Rochester Gas & Electric Corporation
R. E. Ginna Nuclear Power Plant

Improved Technical Specifications

December 1995 Submittal

Attachment C
Chapters 3.5 - 5.0

Figure Relocated
to the COR
20.111

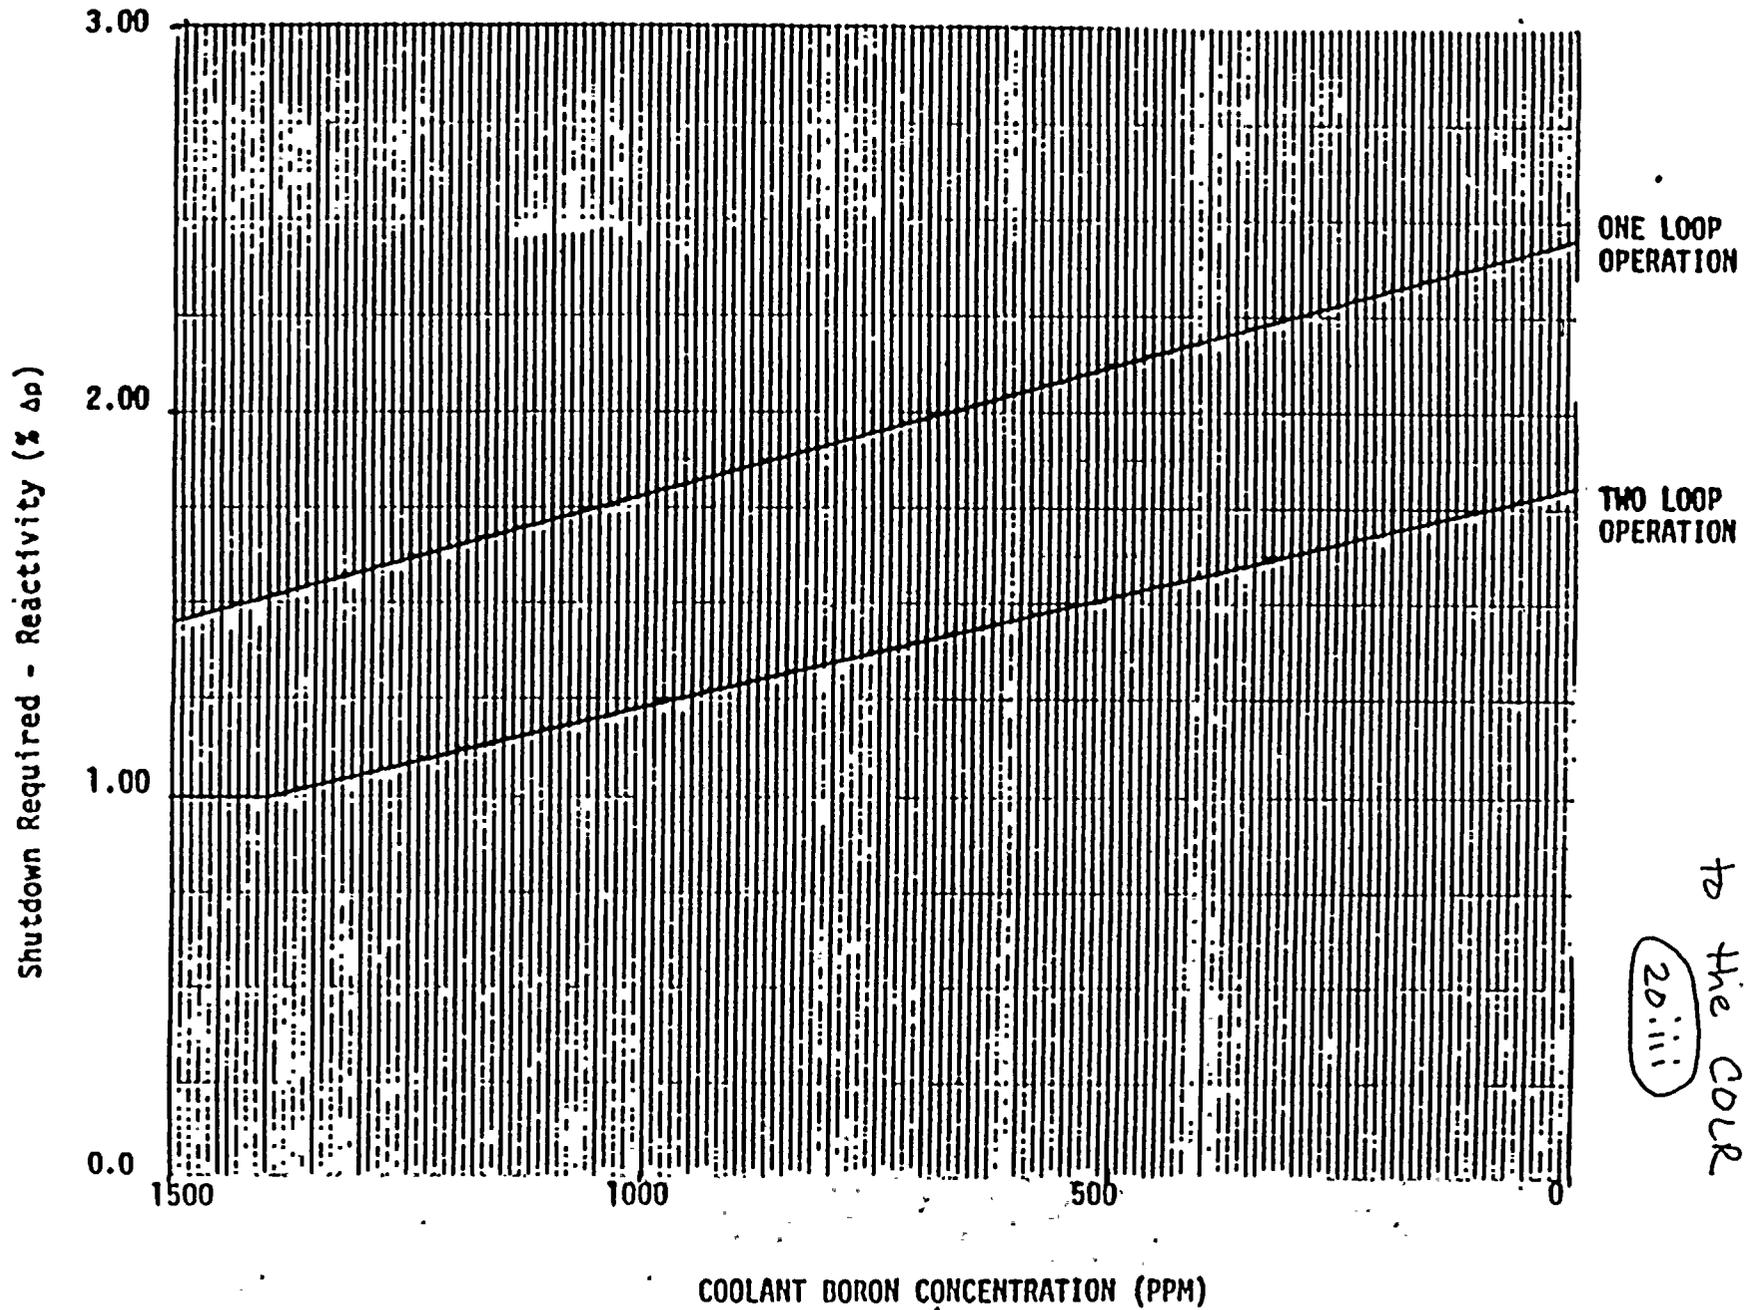
- iii. TS 3.10.1.1 and Figure 3.10-2 - These were revised to relocate the SHUTDOWN MARGIN requirements and Figure 3.10-2 to the COLR. SHUTDOWN MARGIN can be used in fuel management and as a variable to solve plant specific problems. SHUTDOWN MARGIN impacts a number of analyses (i.e., uncontrolled boron dilution and steamline break) and is sensitive to many core related parameters such as control bank position, core power level, coolant temperature and cycle specific parameters such as fuel burnup, xenon concentration and boron concentration. The inclusion of SHUTDOWN MARGIN in the COLR provides more flexibility in plant operation, in performing the design, and in obtaining good fuel economics particularly for extended cycle operation. With the SHUTDOWN MARGIN included in the COLR, the core design can be finalized after shutdown so that the actual end of cycle burnup is known which is particularly helpful when the actual burnup differs from the projected value. This is a Ginna TS Category (iii) change.

FIG. 2.3-1

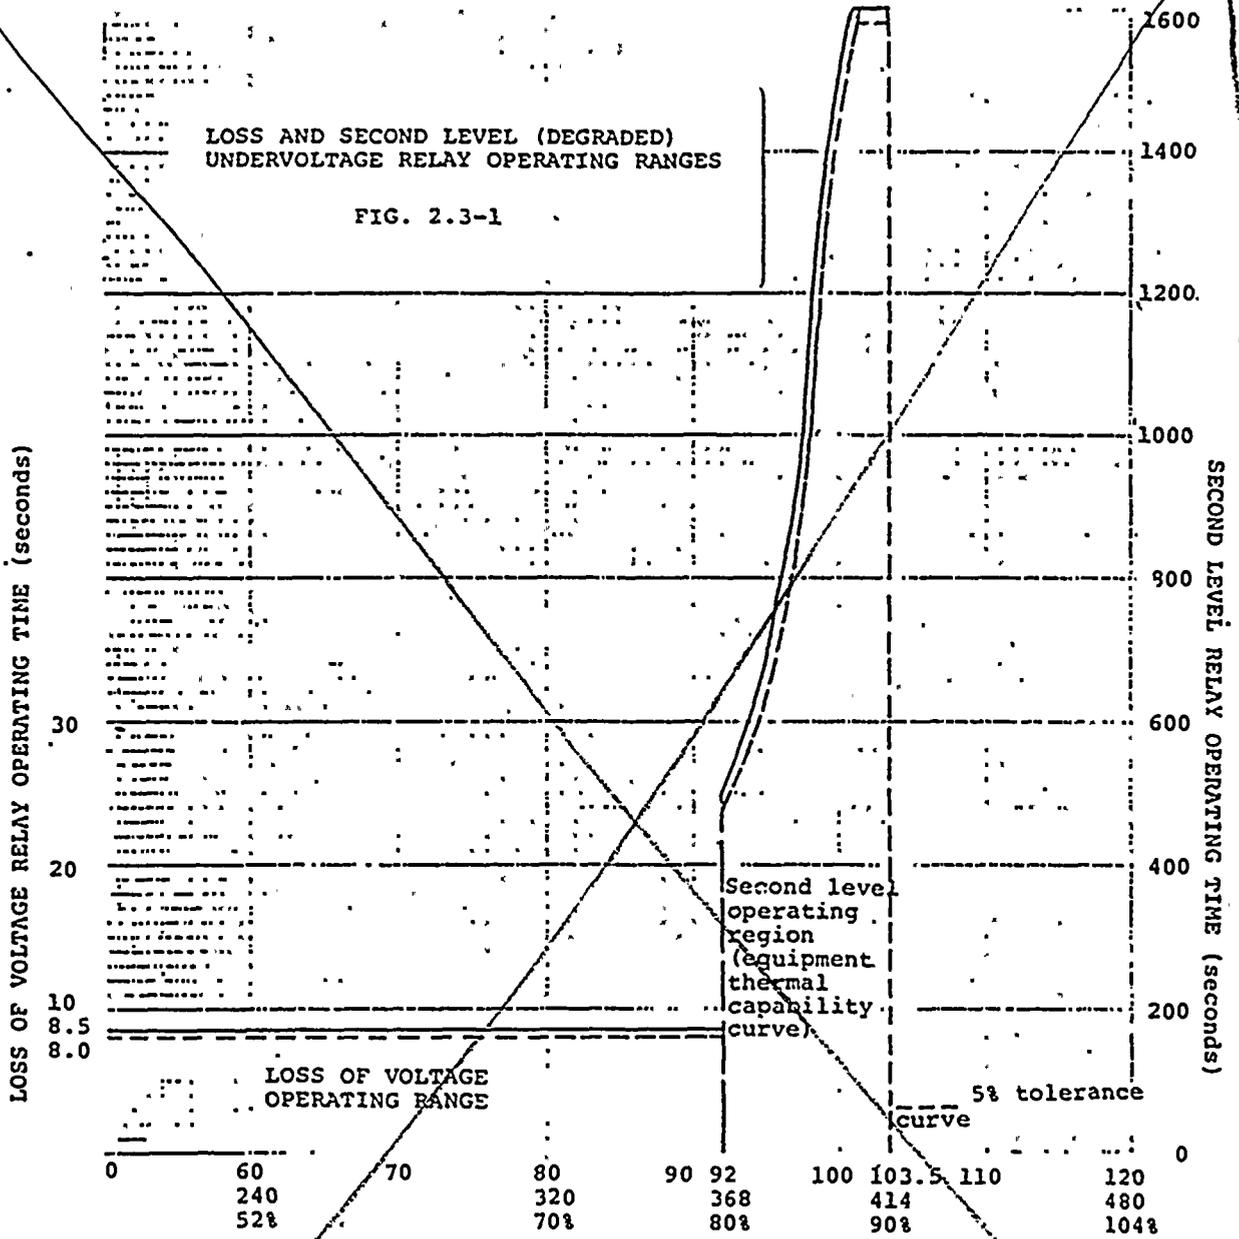
- iv. TS 2.3.3.1, TS 2.3.3.2, and Figure 2.3-1 - The LSSS for the loss of voltage and degraded voltage functions were revised to provide a minimum Trip Setpoint value. Criteria for the establishment of equivalent values based on measured voltage versus relay operating time was relocated to the bases for LCO 3.3.4. This is a Ginna TS Category (iii) change.

Figure 3.1-1: Ginna Reactor Vessel Heatup Limitations Applicable for the first 21 EFPY using Reg Guide 1.99, Rev. 2

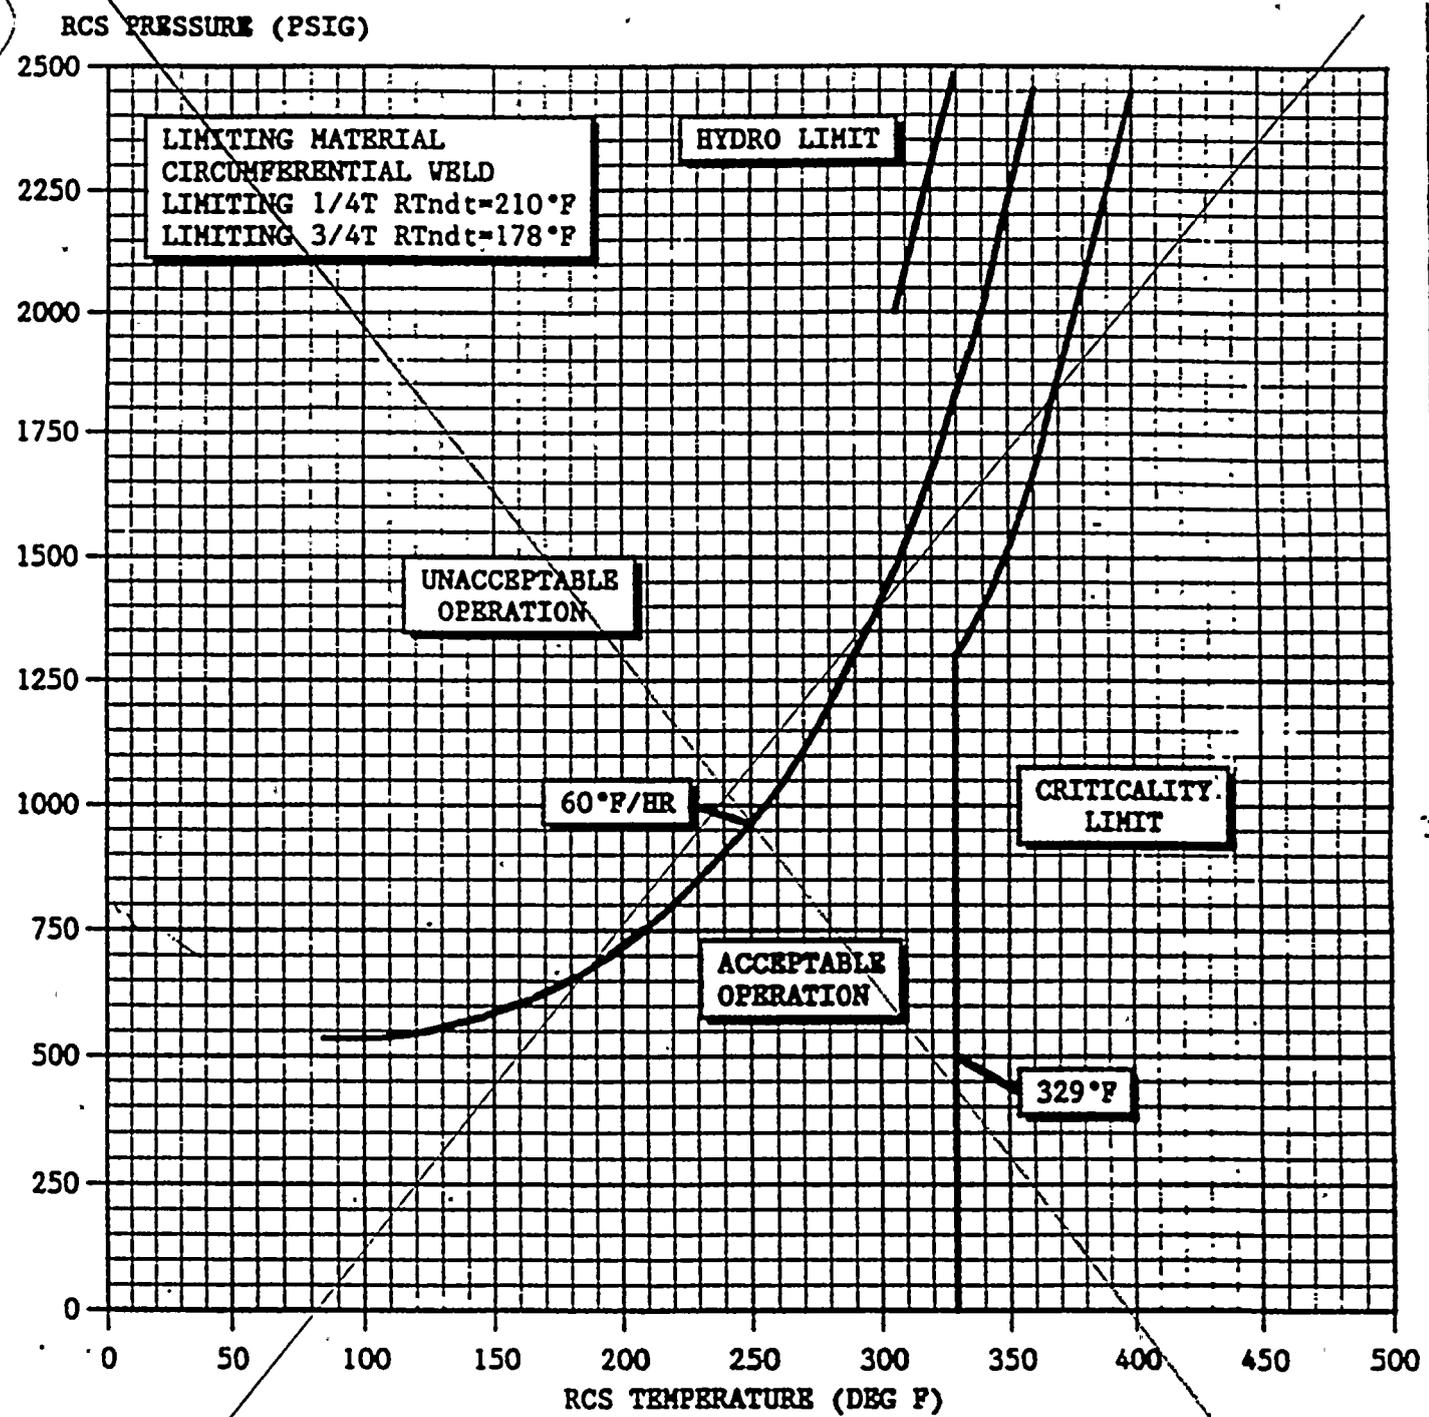
- i. TS 3.1.2.1.a, Figure 3.1-1, and Figure 3.1-2 - The RCS temperature and pressure curves and the RCS heatup and cooldown curves and limits were relocated from technical specifications to the PTLR which is addressed under Administrative Controls. This is a Ginna TS Category (iii) change.

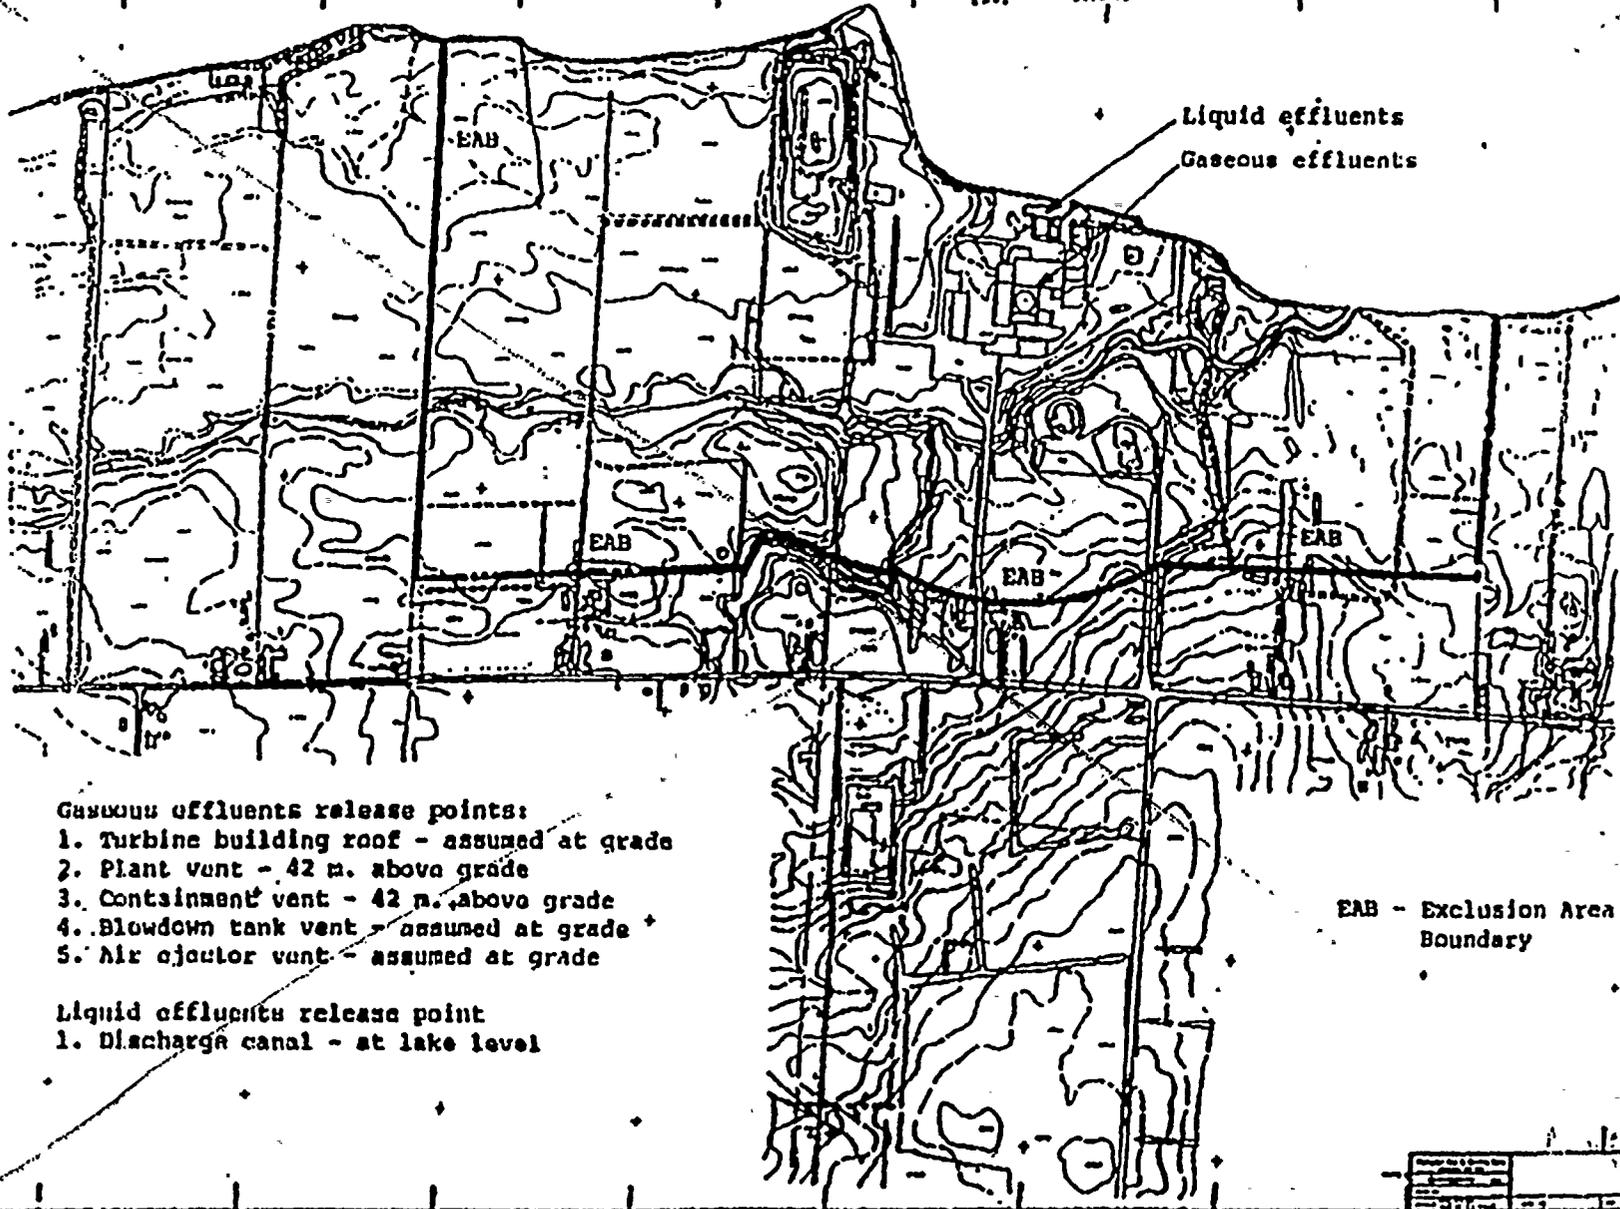
- i. TS 5.1.1, TS 5.1.2, and Figure 5.1-1 - The description and figure of the site area boundary and ~~exclusion area boundary~~ was not added to the new specifications consistent with Traveller CEOG-03, C.1. Since the description of ~~these~~ ²²⁵ ~~this~~ design features ~~feature~~ does not satisfy ~~meet~~ the NRC Final Policy Statement ~~technical specification~~ screening criteria for Design Features described in 10 CFR 50.36, this description is relocated to licensee controlled documents (i.e., UFSAR, Section 2.1.2). ~~This is~~ ¹⁶⁹ ~~The~~ figure and description of the ~~exclusion area boundary~~ was also replaced with a Ginna TS Category ~~(iii)~~ ^{changeable} describing this feature consistent with Traveller CEOG-03, C.1. There are Ginna TS Category ~~(iii)~~ changes.

SPENT FUEL STORAGE RACKS

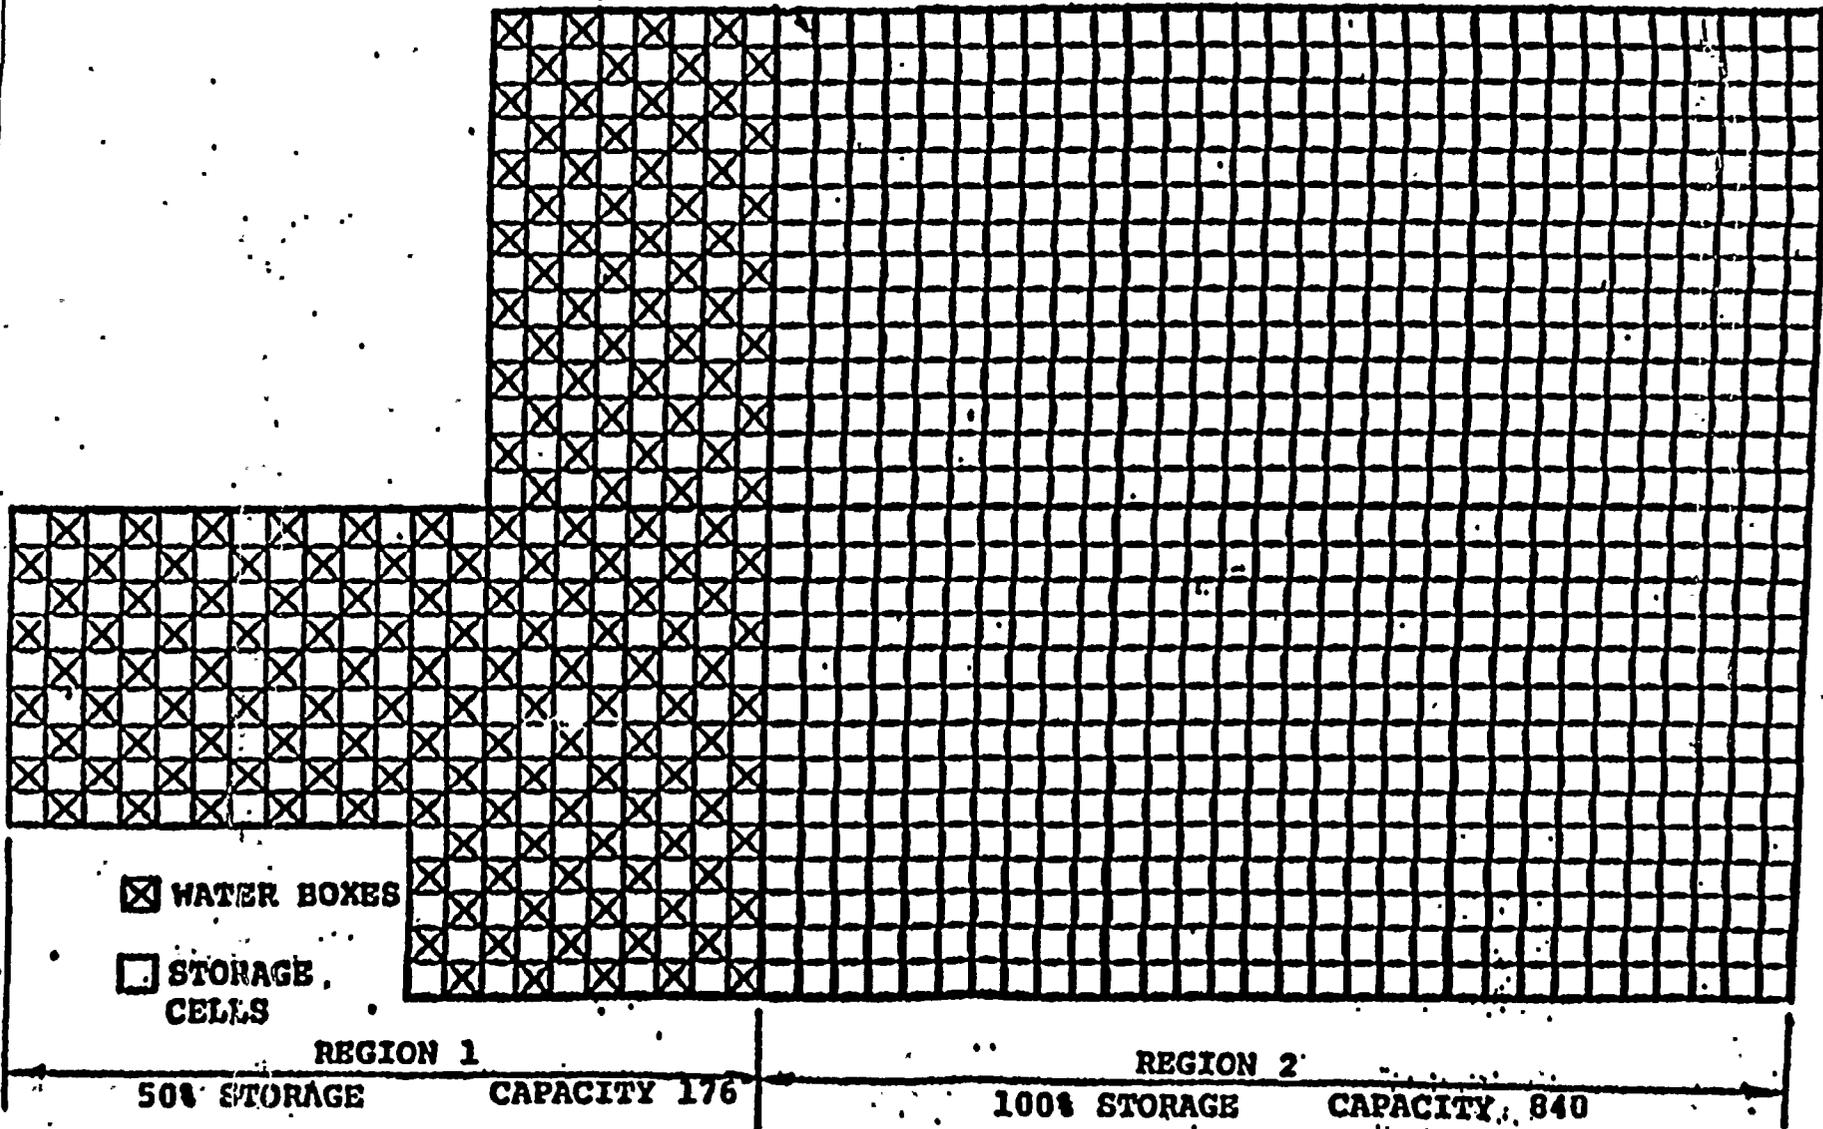
i. TS 5.4.1, 5.4.2, 5.4.6, and Figures 5.4-1 and 5.4-2 - The description of the fuel storage design features denoting spent fuel storage regions and borated water concentrations ~~was~~ were relocated to Chapters 3.7 and 3.9. These features are discussed in ~~LCO, LCO's~~ 3.7.11, ~~LCO~~-3.7.12, ~~LCO~~-3.7.13, and ~~LCO~~-3.9.1 as appropriate. In addition, appropriate Required Actions were added in the event that SFP water level, boron concentration, or SFP region storage requirements are not met. This is a Ginna TS Category (i) change.
